**Flagship Enterprise Center**  
Accelerator Building  
Anderson, Indiana

### Addendum #4 – Flagship Accelerator Building

**Date:** April 1st, 2010  
**Project:** Flagship Accelerator Building  
**Project #:** 09107  
**Pages:** 6 (8-1/2x11) pages  
**Bid Dates:** April 6th, 2010

E1-G

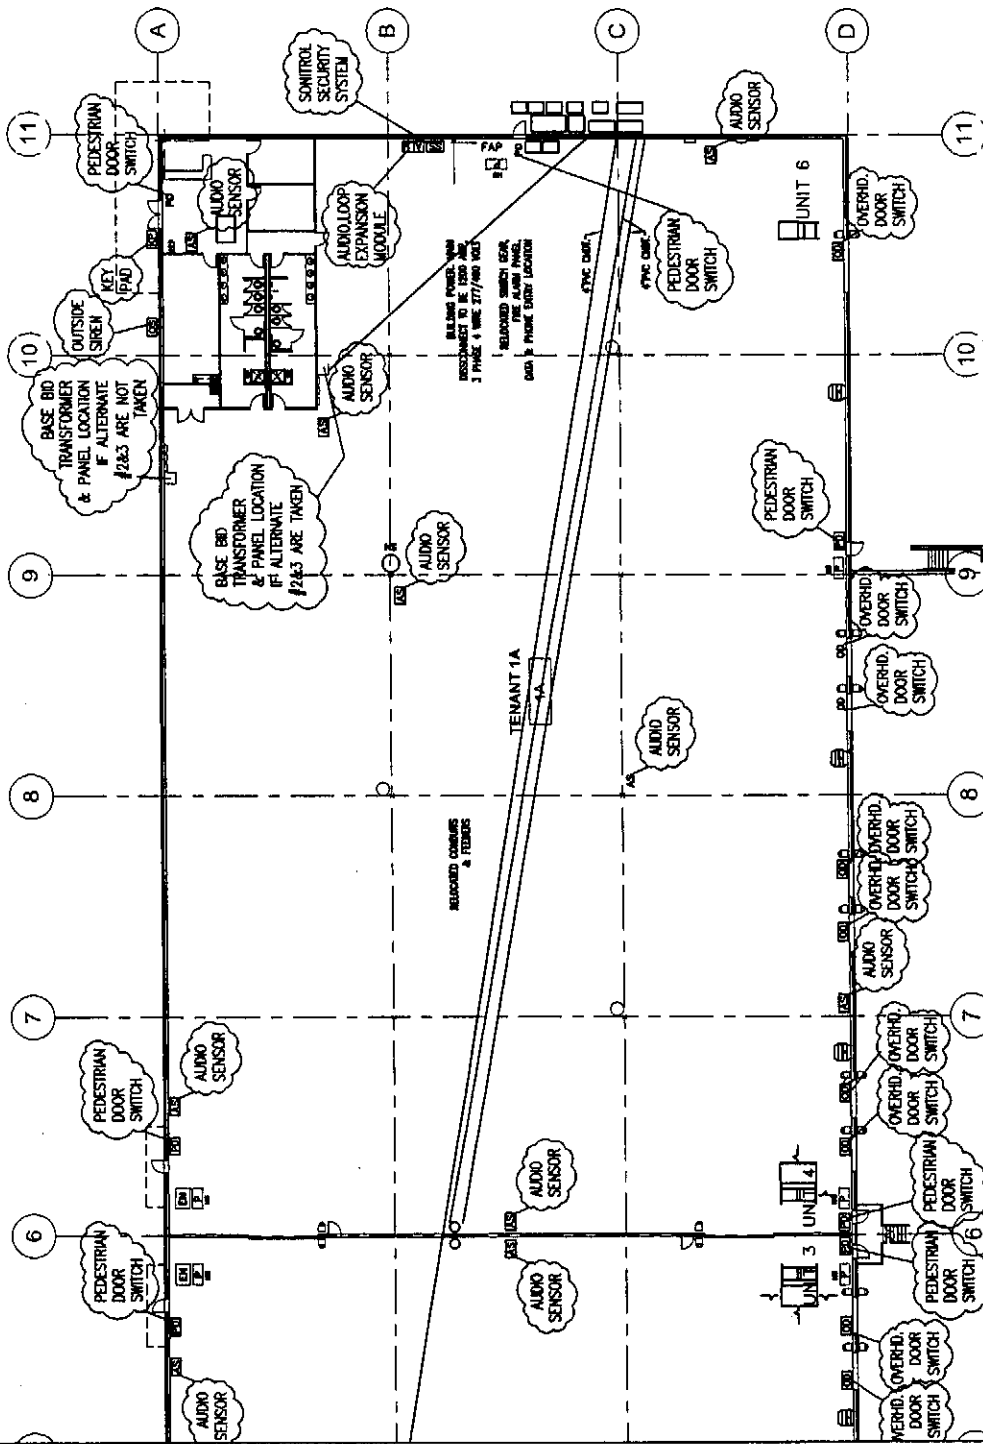
- 1 See 8 ½ x 11 sheets for location of sonitrol security devices.
- 2 Fully piped / conduit system from the Fire Alarm and the Security system.
